PLANNING GROUP REPORT ON PLANS RECEIVED BETWEEN 11/07/2025 – 14/08/2025

7/2025/2141 – Housing Development of 129 Dwellings at Sheepdog Field East of Calvert Way

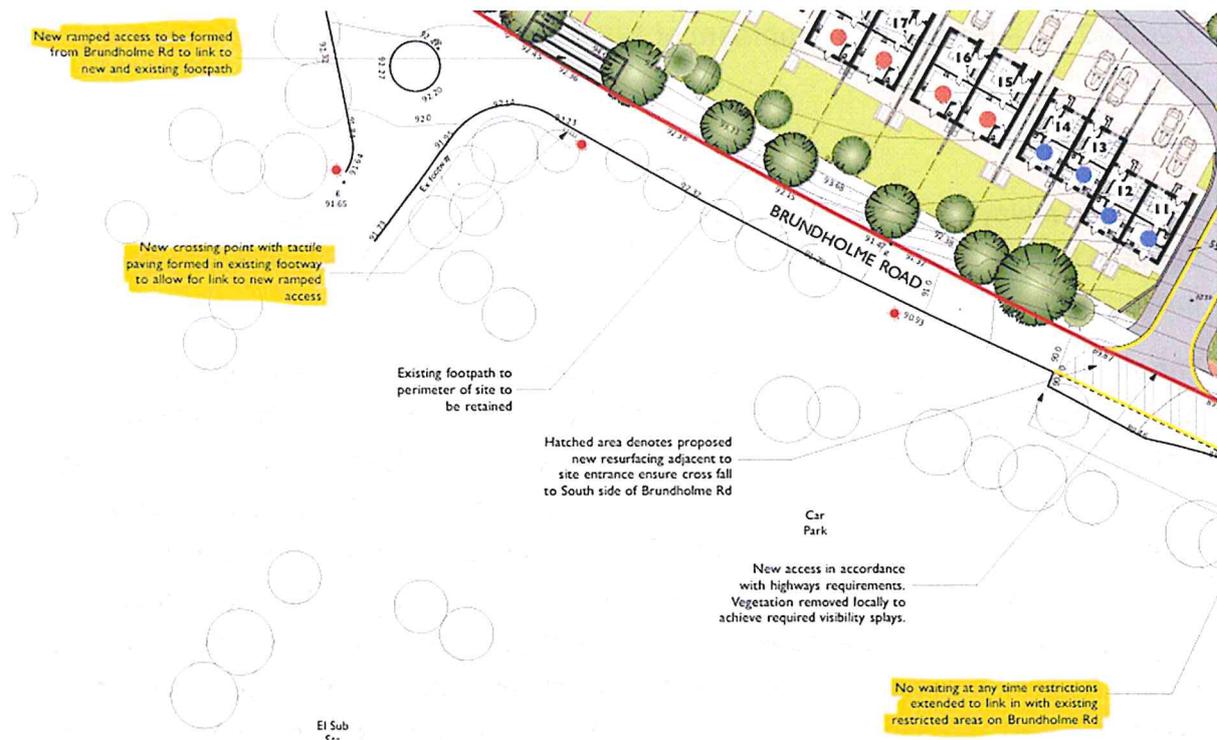
The second issue is the lack of pedestrian footpath provision for Calvert Way residents to safely access the Town Centre. No provision is currently shown on the submitted plans to address the issue, which also affects residents of the new development. This was raised during the planning process for phase 1 (ref 07/2014/2300) and a planning condition was put on the decision notice – point 5 of that document requiring the offsite highway improvements shown on the approved plan 3803 02 Revision A to be implemented within 3 months of the 1st occupation of the development. The development had been occupied for 8 years, and residents are still waiting for these referenced improvements. This included additional double yellow lines, a ramp, and tactile paving, highlighted in yellow on the screenshot of the referenced document below.

We recommend that a new footpath is built along Brundholme Road providing a continuous link from the existing footpath at Brundholme Gardens bridge and the access to the leisure centre near the mini roundabout. Safe pedestrian crossings should also be provided from the Calvert Way access, all as recommended in Cumberland Highways response of 01.08.2025. As this is work outside the application boundary, planning permission should not be granted without a clear undertaking agreed with Cumberland Highways to this provision as an essential requirement to provide safe pedestrian access to the Town Centre.
